2001 RICHMOND STREET

CIVIC DESIGN REVIEW
10.06.2026

Subject: Civic Design Review Key Recommendations Response
2001 Richmond St / Application #ZP-2026-004864
ISA Project No. 2206

ON-STREET PARKING

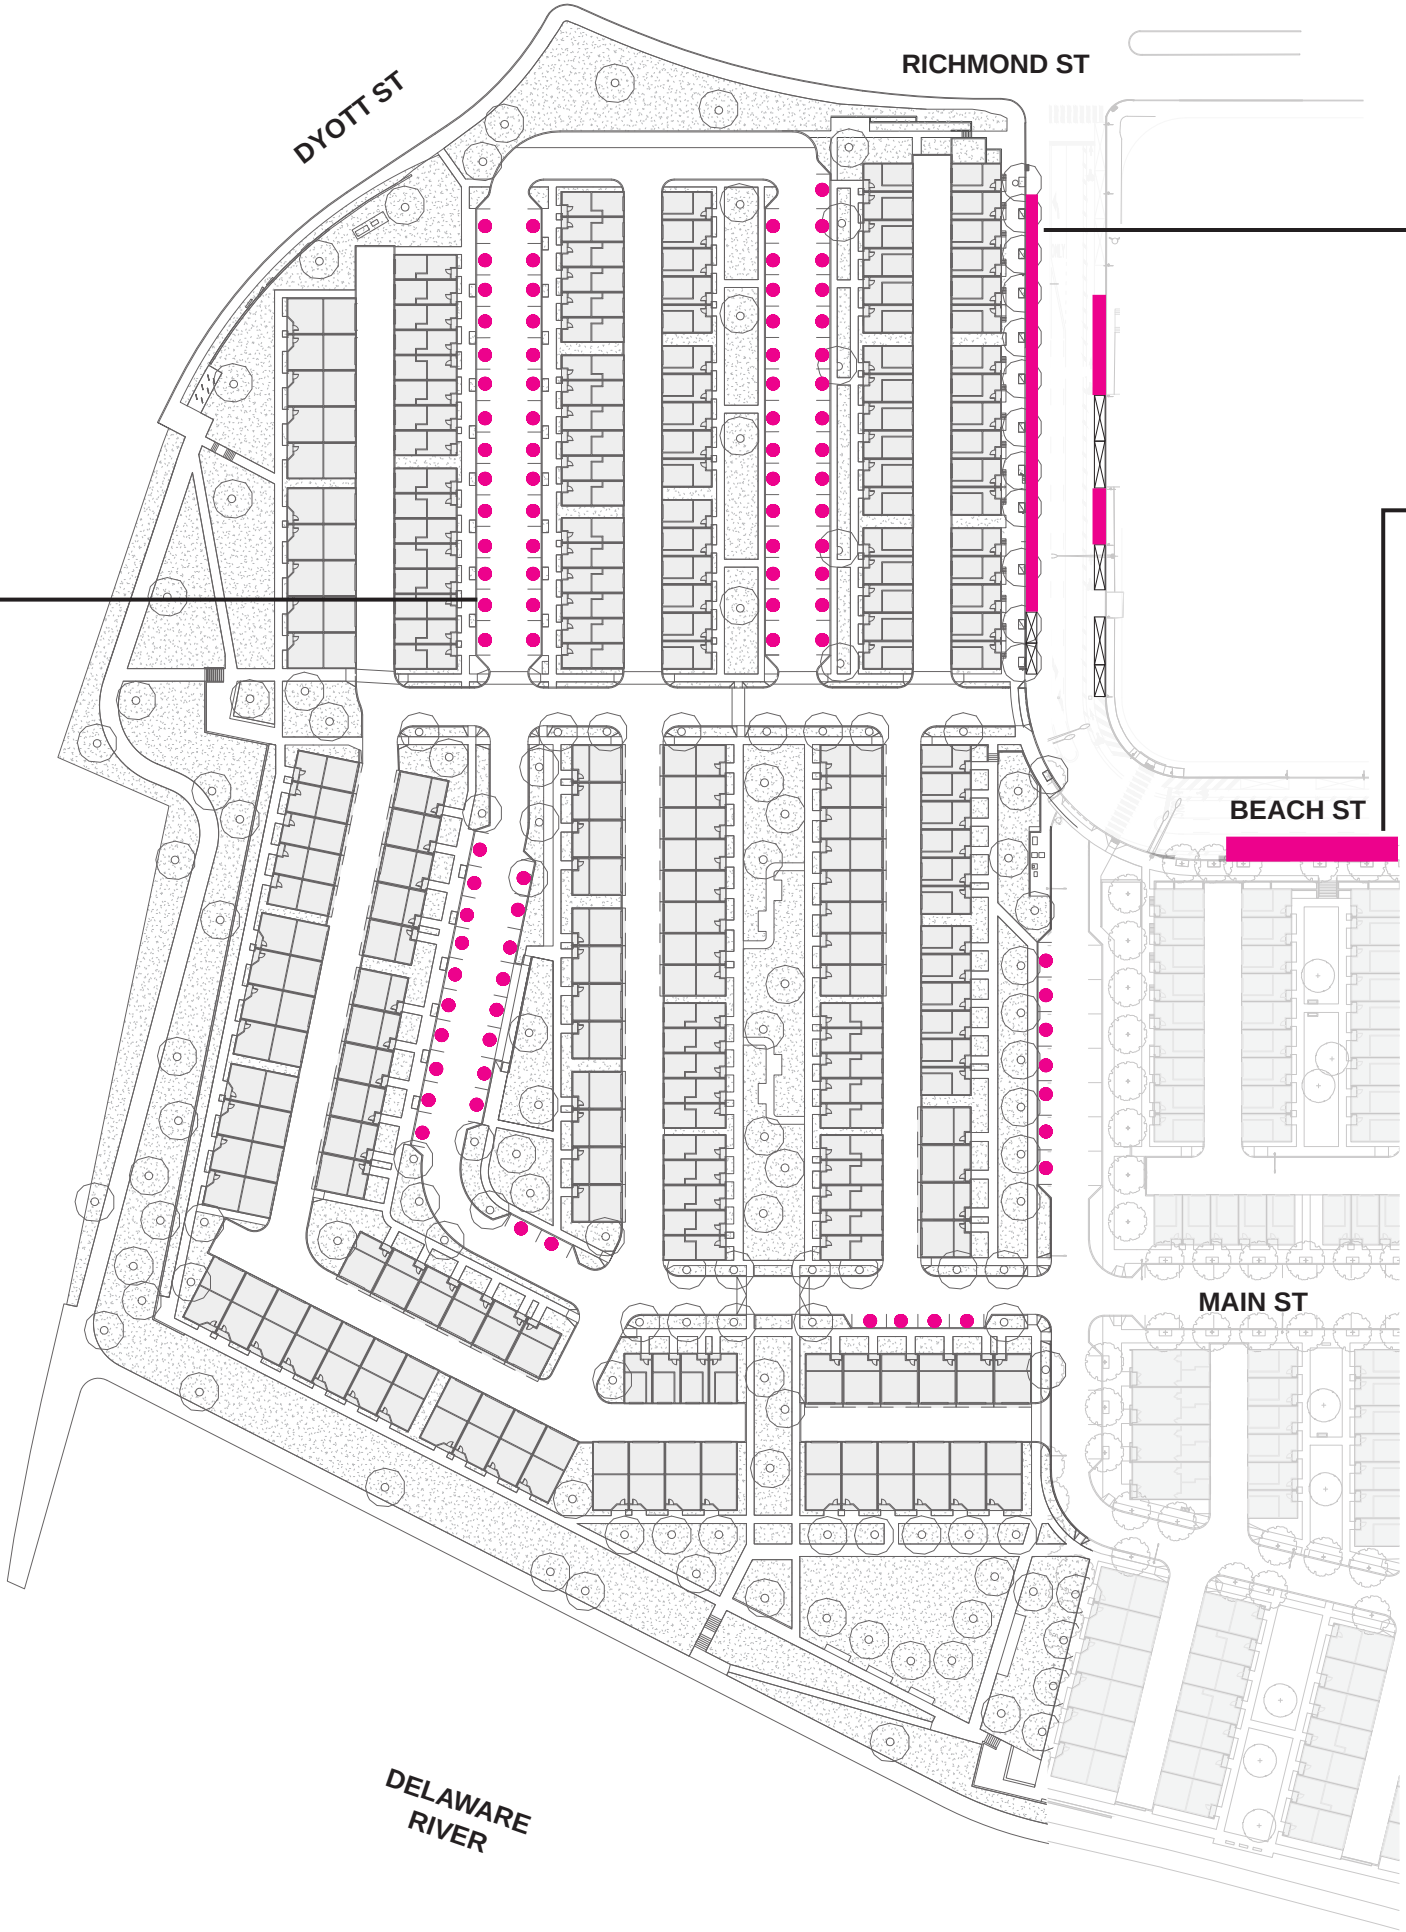
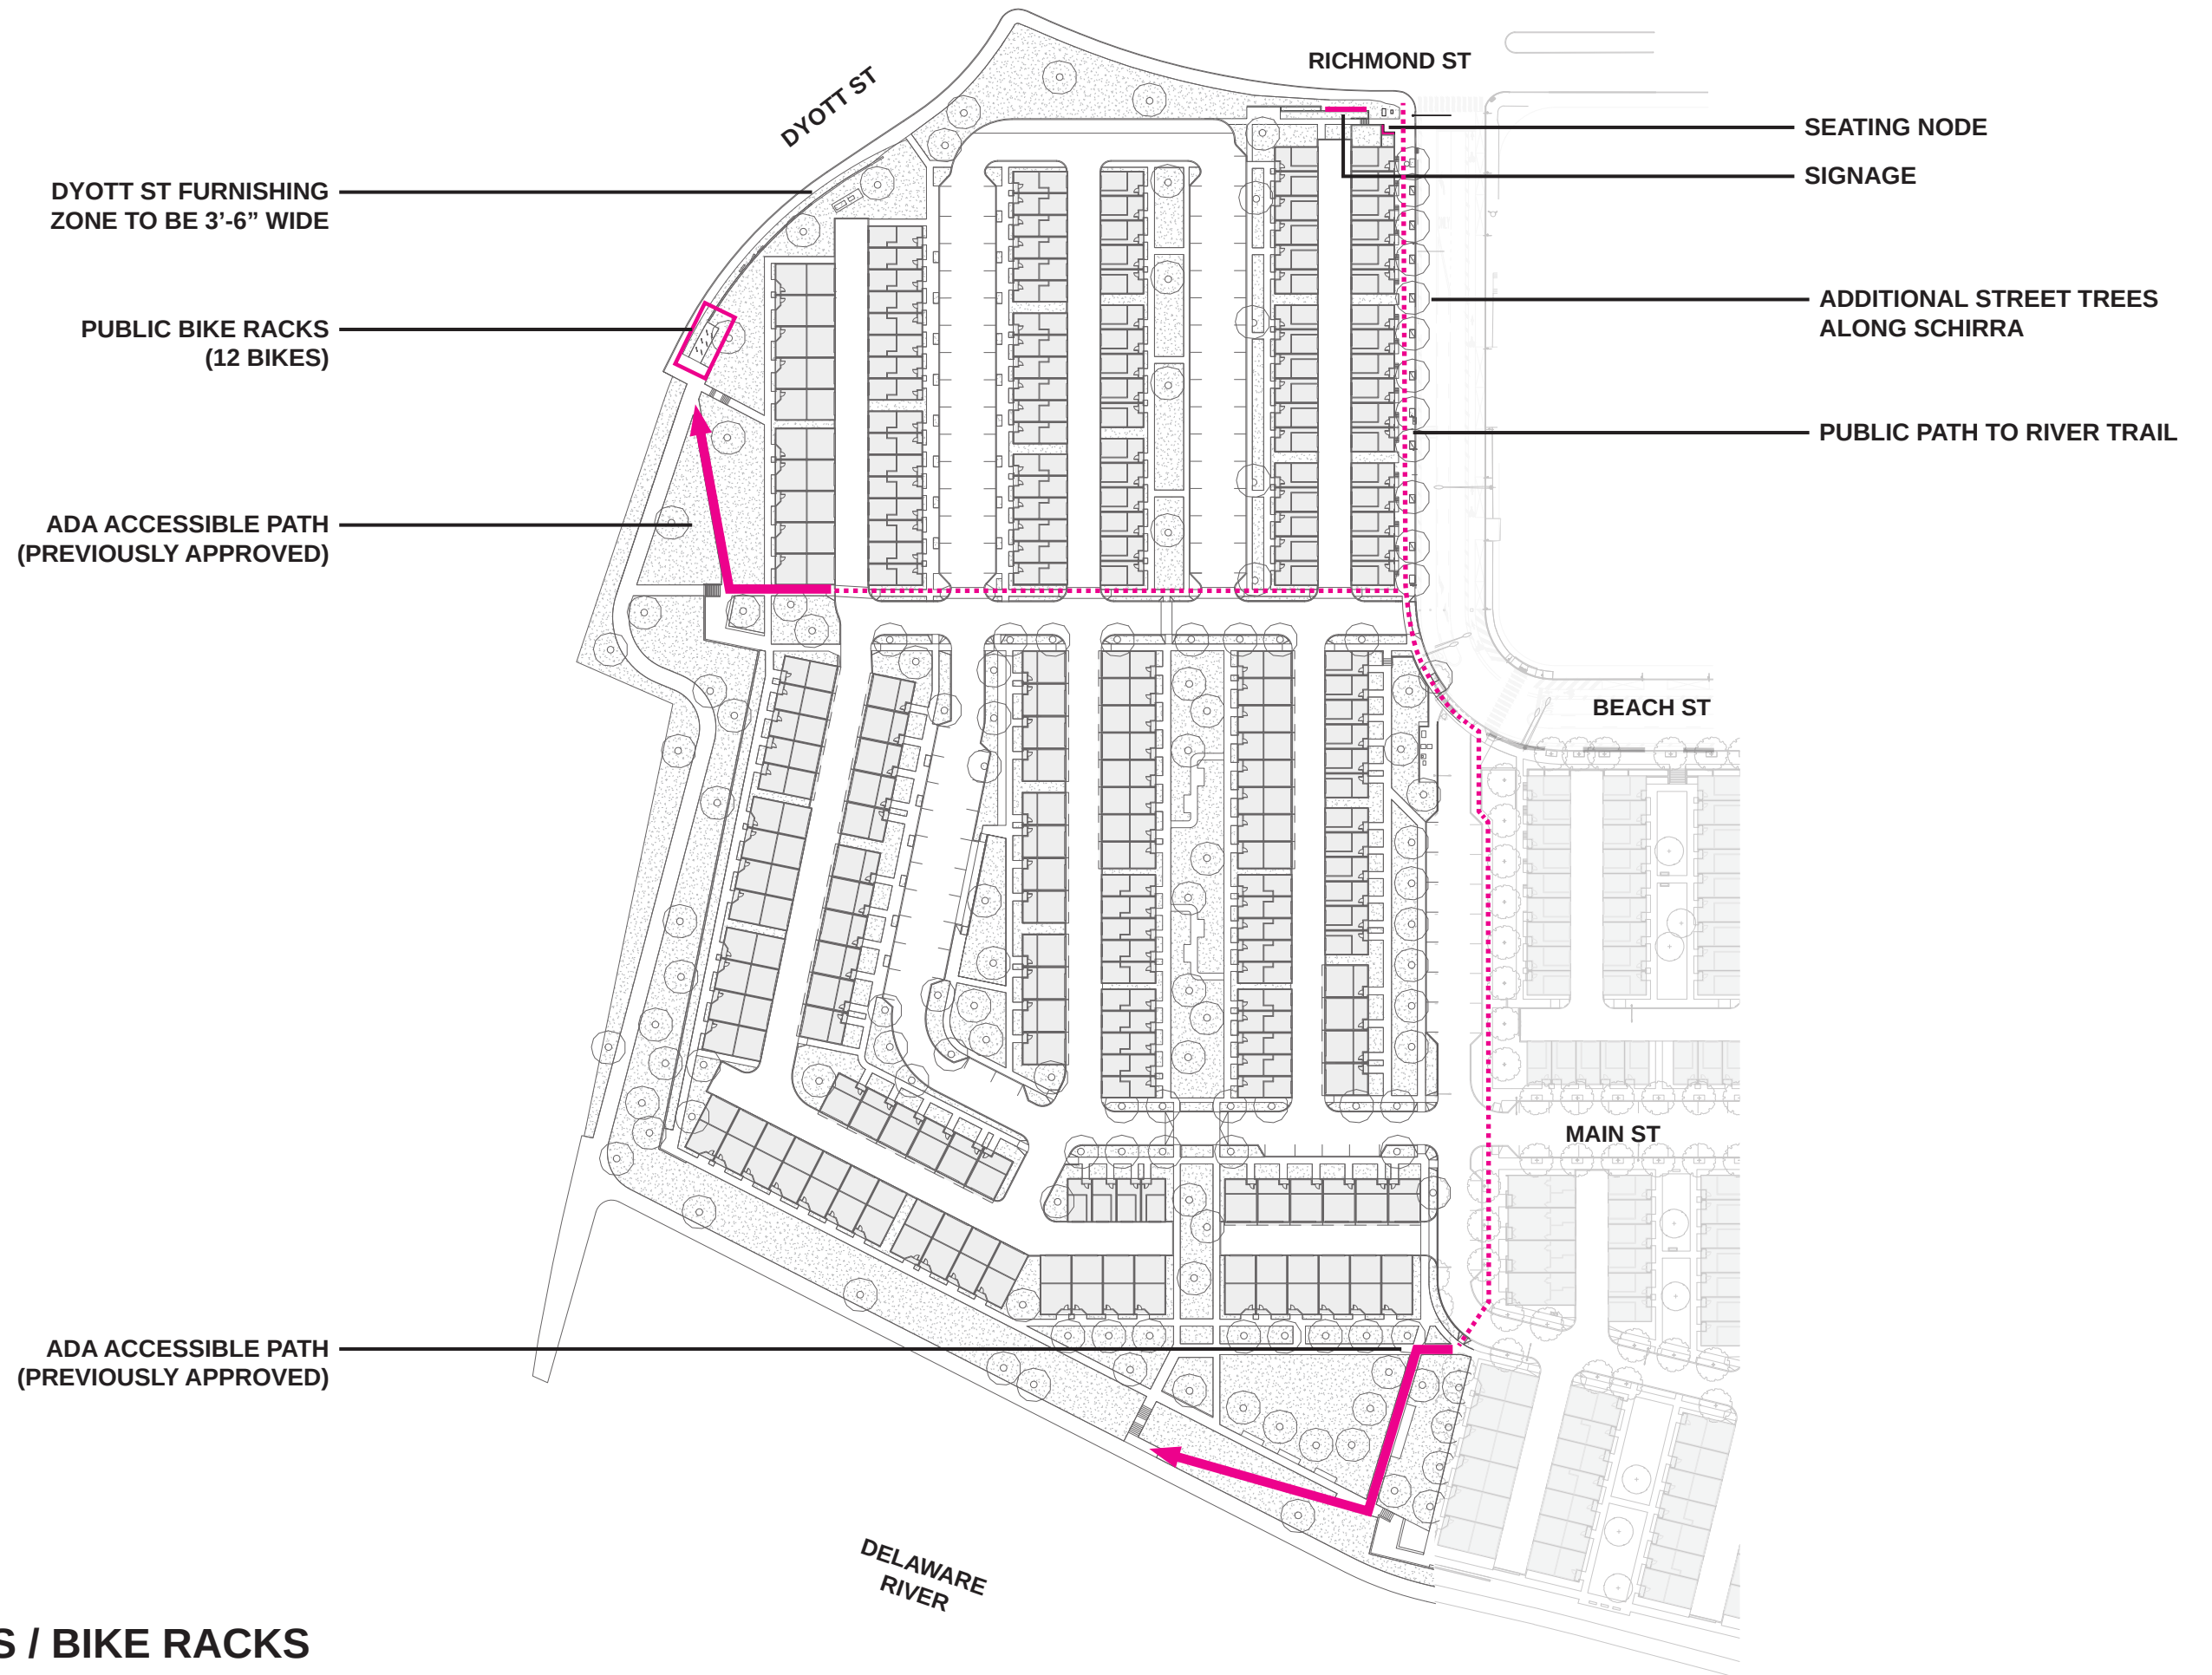
4. Notes on-street parking also intended. (Please confirm locations on revised plans).

16. Consider how small reduction of on-street parking could create significant opportunities for added amenities, such as a playground, sports courts, commercial space, or a community room.

An updated site plan diagram is included with the revised submission to more clearly identify on-street parking locations, both within the community and on surrounding city streets.

This comment is in conflict with the feedback received from residents of the community, who are in favor of more on-street parking. An updated site plan diagram is included with the revised submission to more clearly identify on-street parking locations, both within the community and on surrounding city streets. No changes to parking are proposed.
